Tennessee Valley Authority, Post Office Box 2000, Soddy-Daisy, Tennessee 37384-2000

**SEQUOYAH NUCLEAR PLANT (SQN) - AMERICAN SOCIETY OF MECHANICAL
ENGINEERS (ASME) SECTION XI INSERVICE INSPECTION (ISI)
PROGRAM - RELIEF REQUESTS**

Request for Relief 1-ISI-23

Request for Relief 1-ISI-24 and 2-ISI-24

Examination Limitation Drawing Typical of Unit 1 and Unit 2_
Request for Relief 1/2-ISI-25

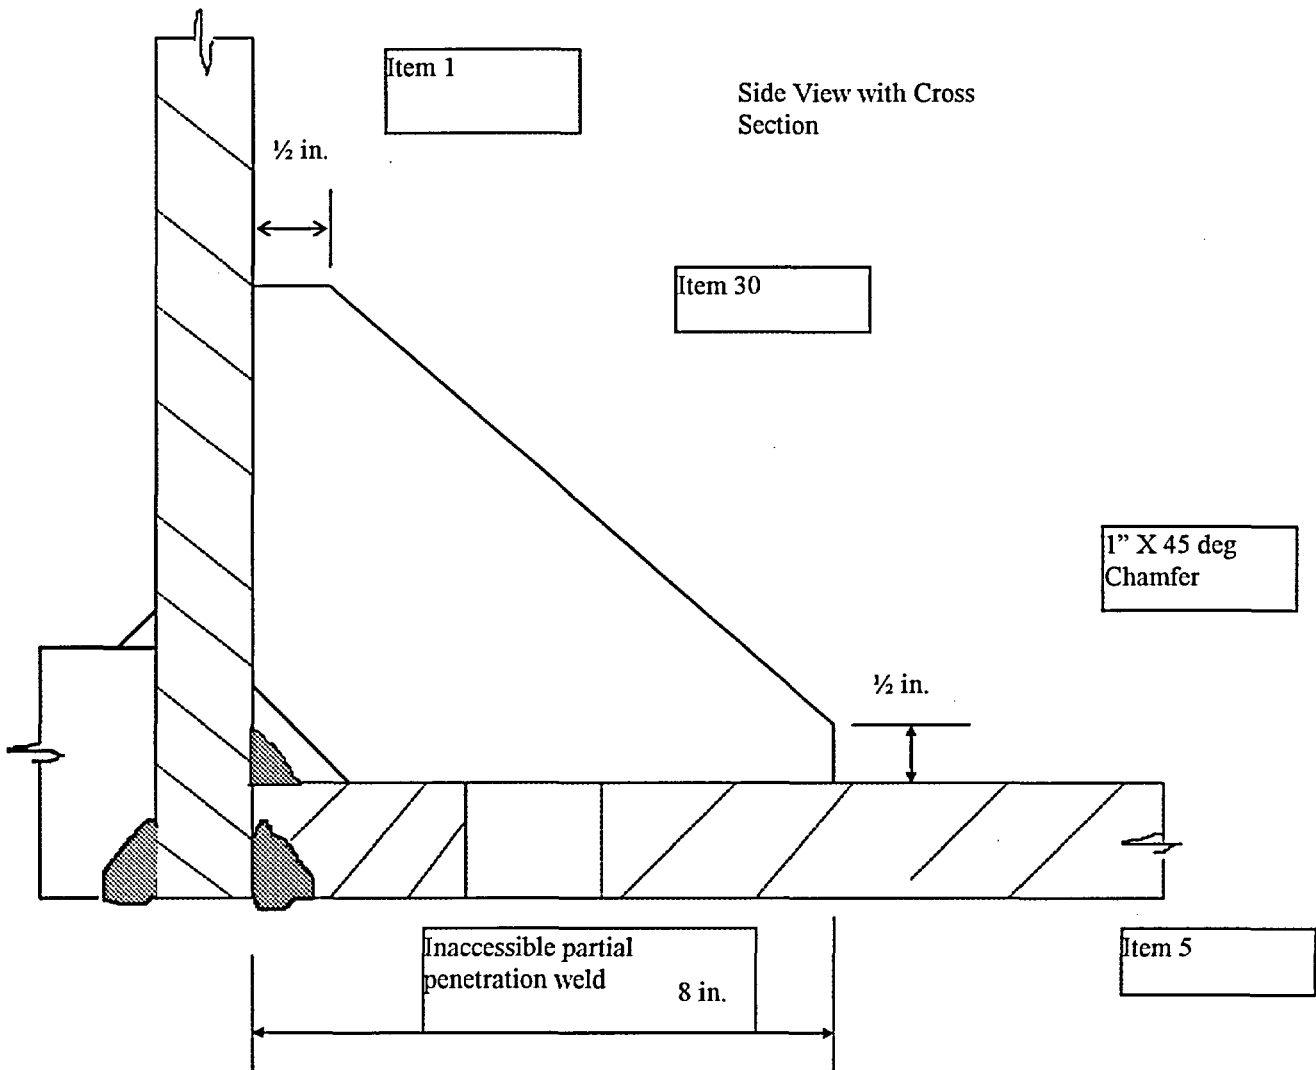
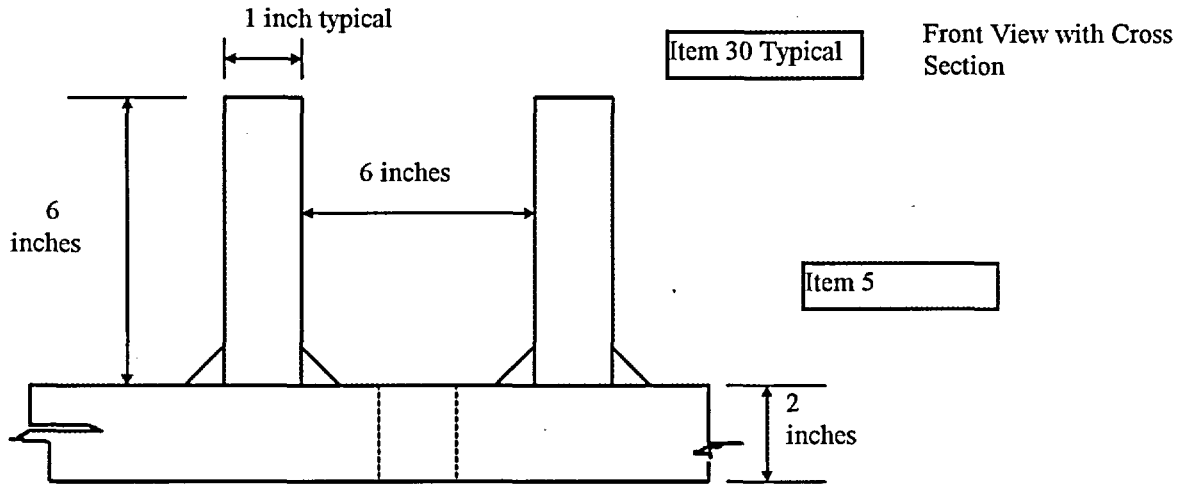
The high percentage (75%) of the VT-1 visual examination of the subject weld areas and adjacent base metal was obtained. This examination coverage provides reasonable assurance of an acceptable level of quality and safety. The weld areas examined provide sufficient information to judge the overall integrity of the weld. Significant degradation, if present, would be detected during the VT-1 visual examination of the subject weld.

PIPE SUPPORT DRAWING
1-SIH-801
FOR REQUEST FOR RELIEF
1-ISI-23

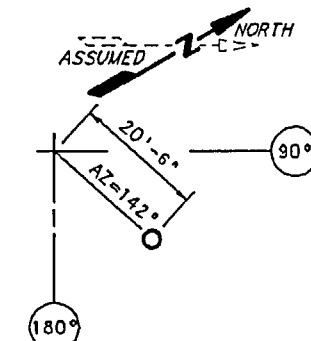
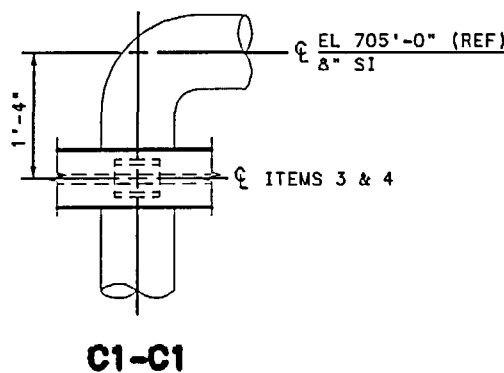
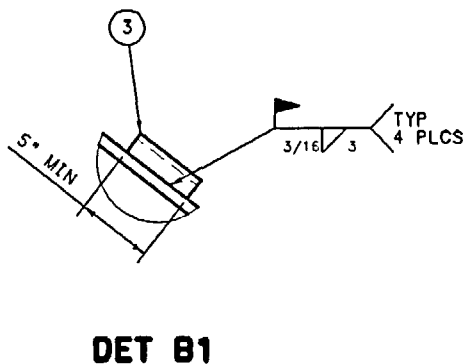
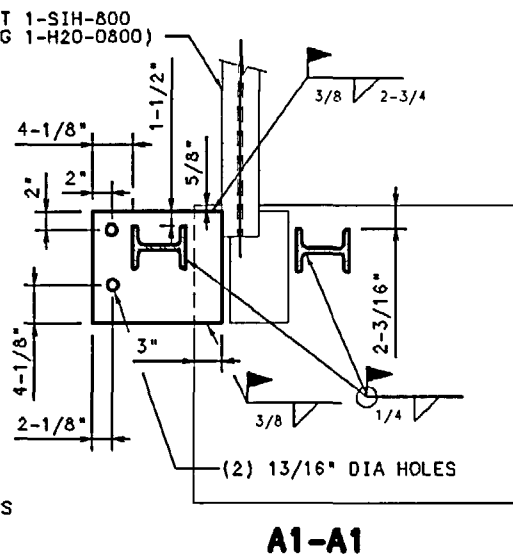
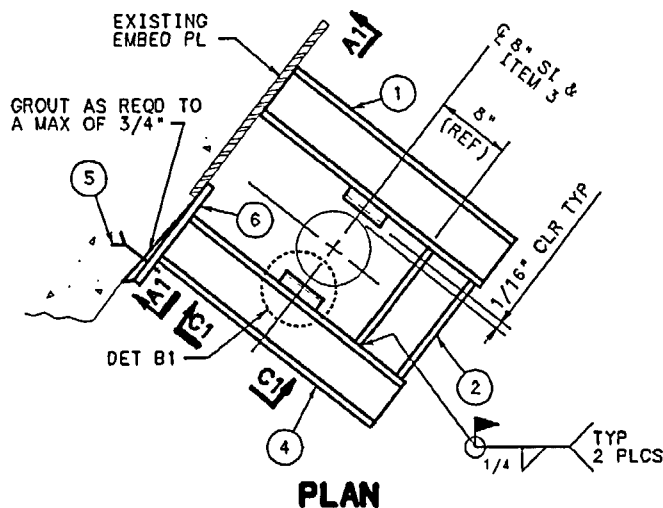
The design configuration used in the fabrication of the subject piping in conjunction with the permanent rigid pipe support (1-SIH-801) precludes ultrasonic examination of essentially 100% of the required examination volume. In order to examine the welds in accordance with the code requirements, the RHR system pipe support would require extensive modification. RHRF-107 is limited at two locations due to a permanent rigid support (1-SIH-801) plate which limits the access from the elbow side for a total of 8 inches. One plate is located on the inside radius of the elbow and is approximately 5 inches in length. The other plate is located on the outside radius of the elbow and is approximately 3 inches in length. The design configuration limits the best effort ultrasonic examination to approximately 72% for weld RHRF-107. The subject weld was examined using application of the best available ultrasonic technology.

Radiographic examination as an alternate volumetric examination method was determined to be impractical because the same plates that limit ultrasonic examination also obstruct film placement.

(ASME Code, Section XI, Figure IWB-2500-13)

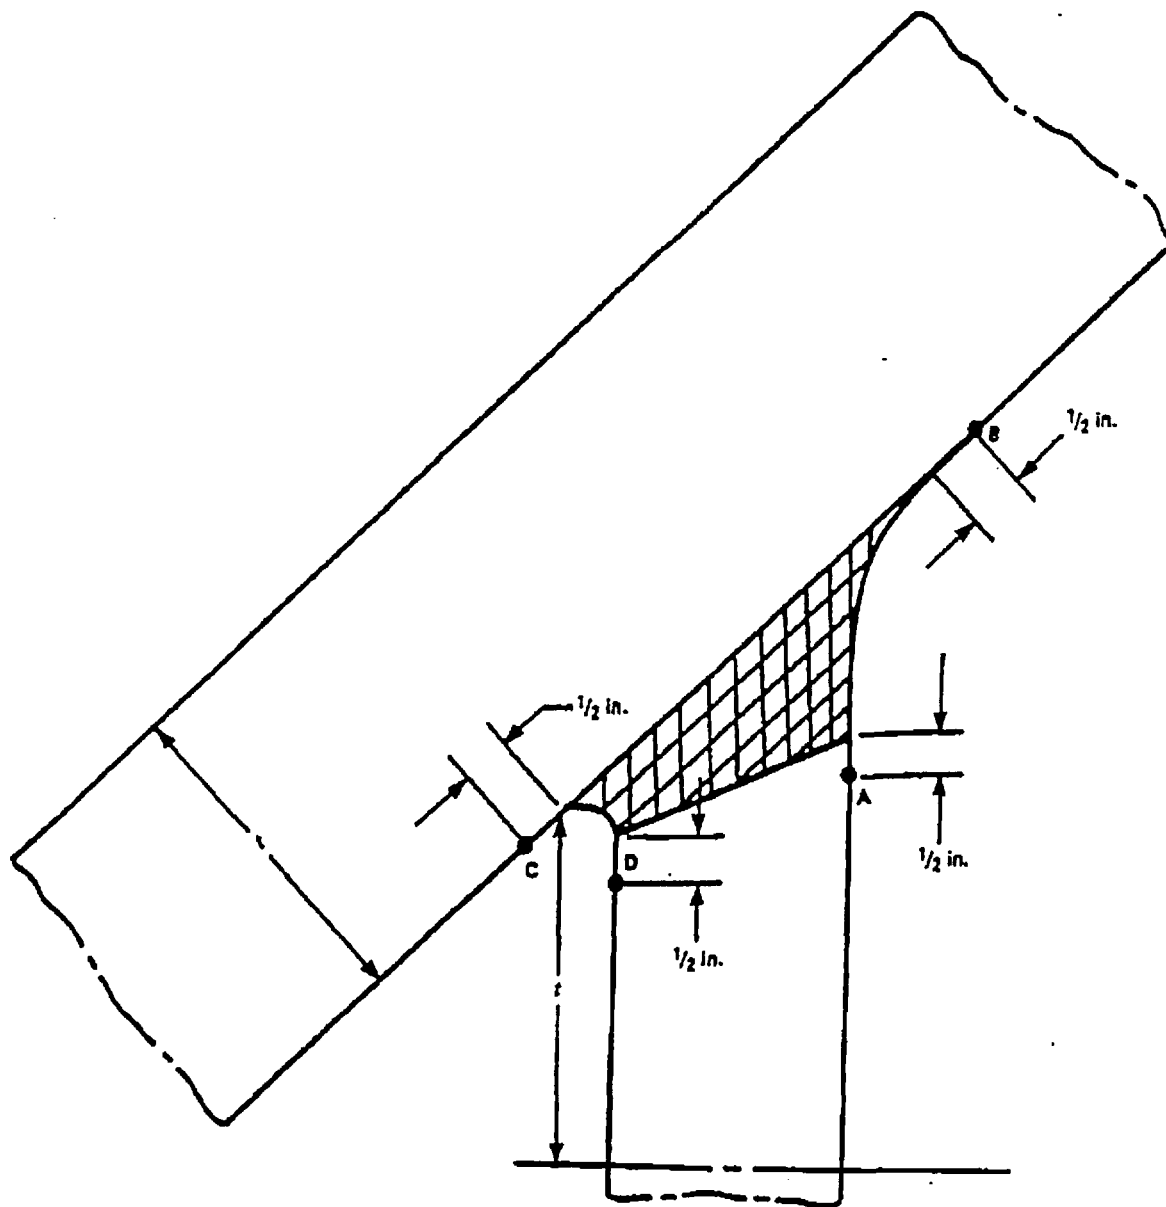
The reactor pressure vessels (RPVs) at BFN are supported on cylindrical skirts that are welded to the bottom RPV heads as shown in Figure 1. The Code requires that both surfaces of the weld be examined. An examination of the outside weld surface is readily accomplished with minimal, if any, hindrance. However, examination of the inside weld surface is difficult. The only access into the skirt is through an 18-Inch opening. Inside the skirt, the weld and bottom RPV head are covered by insulation. The tasks of removing this insulation, preparing the weld surface for examination, and performing the examination are hindered by limited maneuverability in the confined space within the skirt. The confined space also houses the control rod drive mechanisms (CRDMs) that are attached to the bottom RPV head. The CRDMs further contribute to the limited maneuverability. Because of these limitations, the time needed to complete an examination of the weld surface would expose inspection personnel to high radiation dosages. The licensee estimated that the total radiation to personnel involved with preparing and examining the weld surface would total 11.2 rem.

The licensee proposes to perform a best-effort ultrasonic (UT) examination from the outside (accessible) weld surface to detect service related flaws on the inside weld surface. The best-effort UT examination would replace the required inside surface examination. The licensee believes that this alternative would provide an acceptable level of quality and safety.

The ASME Code specifies different examination requirements for the skirt weld configurations depicted in Figures 1 and 2. The Code requires surface examinations of both the outside and inside welded surfaces for the Figure 1 configuration. The inside examination requires personnel entry to the area inside the skirt. For the Figure 2 configuration, the Code allows (1) a surface examination for the accessible side, and (2) a volumetric examination from the accessible side of the inaccessible side. This does not necessitate personnel entry to the area inside the skirt.

The staff concludes that the proposed alternative described above will provide an acceptable level of quality and safety. Pursuant to 10 CFR 50.55a(a)(3)(i), the staff hereby authorizes the proposed alternative as described in Section 3.0 above. The proposed alternative is authorized by law and will not endanger life or property or the common defense and security and is otherwise in the public interest.

FIGURE 3
(BROWNS FERRY)

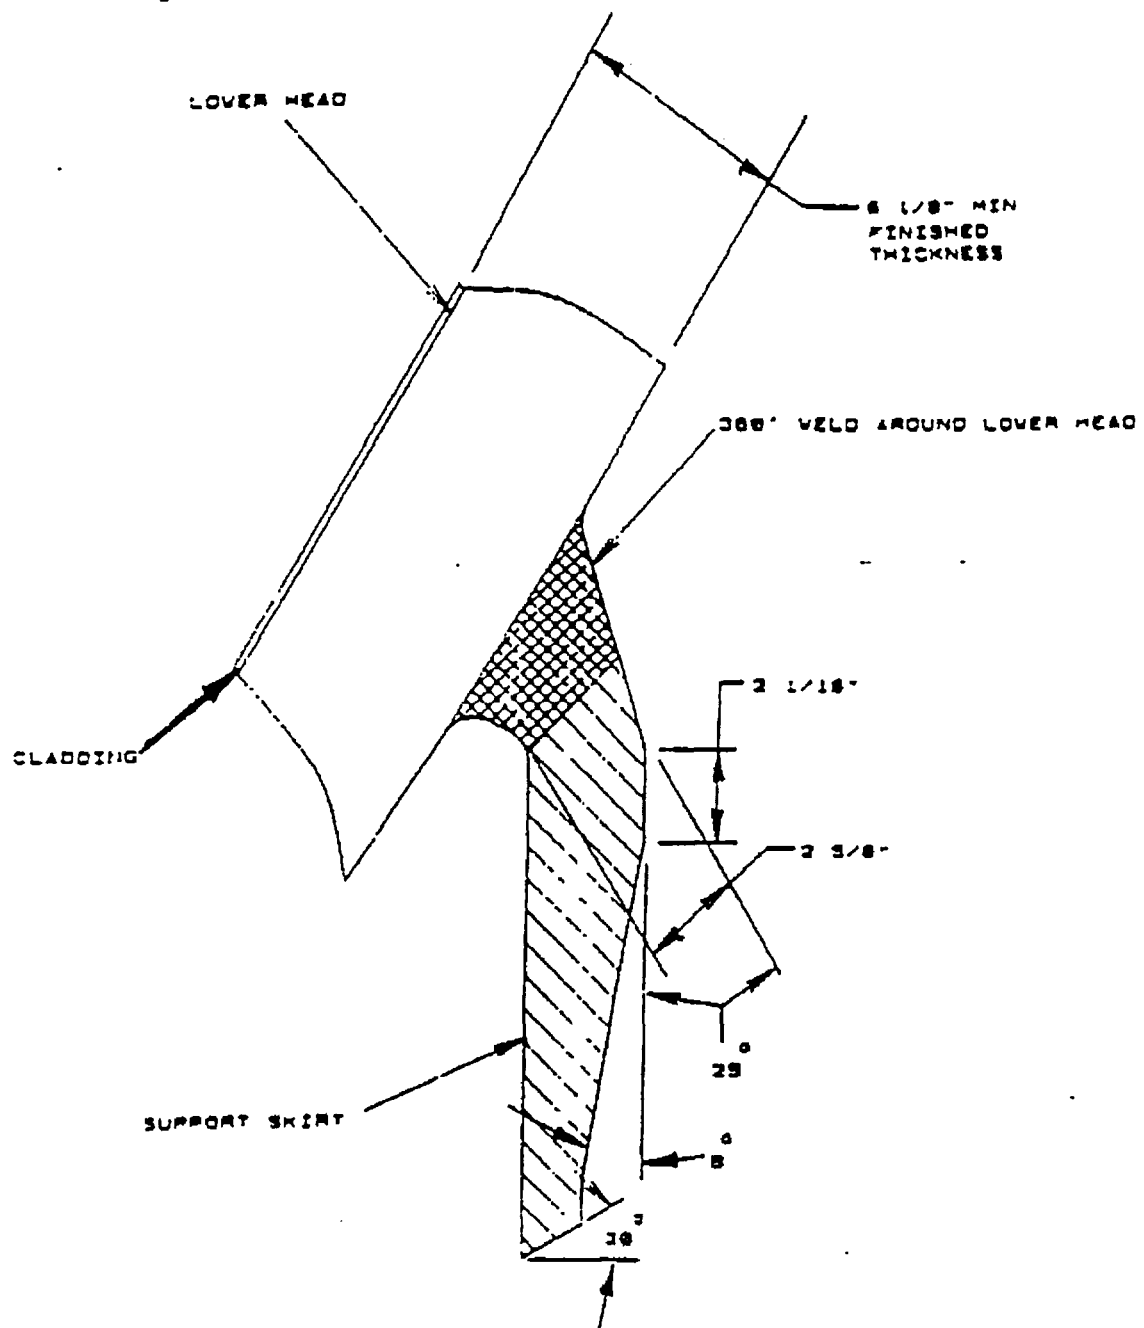
The skirt weld configuration at BFN is shown in Figure 3. This configuration is a hybrid of Figures 1 and 2. Instead of performing surface examinations from both sides of the welds in accordance with the Code requirements applicable to the Figure 1 configuration, the licensee proposes to perform (a) a surface examination on the outside surface (accessible) of the welds and, (b) a best-effort UT examination of the inside surface of the welds, from the outside surface.

This licensee's proposed alternative for its Figure 3 skirt welds is similar to the Code requirements applicable to the Figure 2 configuration. The Figure 3 configuration can, to a significant extent, be volumetrically examined from the outside surface, as is the case for the Figure 2 configuration. The weld volume capable of being examined is through wall and at or near the inside weld surface. Therefore, any crack propagating from the inside weld surface would be detectable. The staff believes that a best-effort examination, in combination with the outside surface examination of the skirt weld will provide reasonable assurance of structural integrity and an acceptable level of quality and safety.
